# Construction Traffic Management Plan

## Patons Lane – Gate 2

### Western Sydney Airport – Surface and Civil Alignment Works

<b>Project Name</b>	Sydney Metro – Western Sydney Airport, Surface and Civil Alignment Works
<b>Project Number</b>	N81150
<b>Revision Date</b>	20 <sup>th</sup> Sept 2022
<b>Revision</b>	D
<b>Document Number</b>	SMWSASCA-CPU-1NL-NL000-TF-PLN-000003

Figure 7: Early works site gate

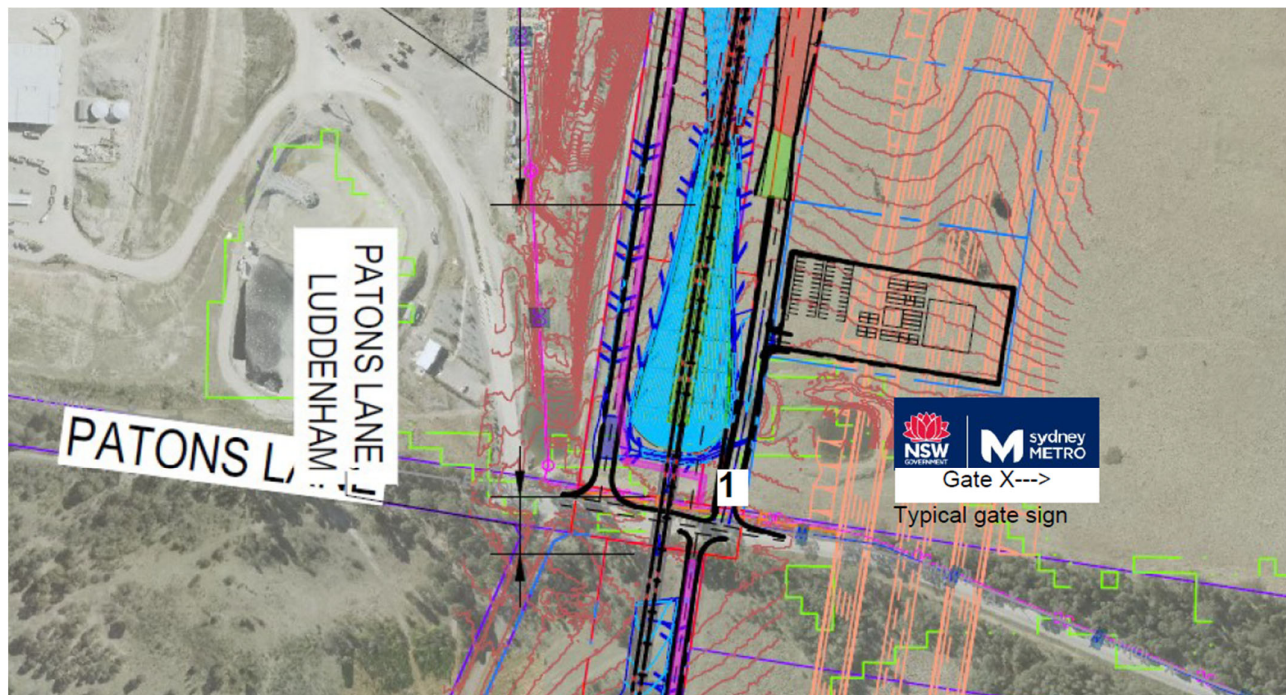
02.01.01	31/08/2022	SMD	BGORDON				This comment remains open. Figure 7 is still not a site layout, there is no mention of any signs, for example STOP signs for vehicles exiting, truck turning signs. It is good to see a PROJECT sign. It also appears another gate has been added since Rev A of this CTMP. This gate should be treated as detailed above.	Potential Non-Compliance	Y
												Potential Non-Compliance	Y

02.01	30/08/2022	CPU	TCHELVARAJ	SMWSASCA-CPU-1NL-NL000-TF-PLN-000003	Figure 2	.	Refer to Figure 7	Potential Non-Compliance	Y
								SMWSASCA-CPU-1NL-NL000-TF-PLN-000003	Figure 2	.		Potential Non-Compliance	Y
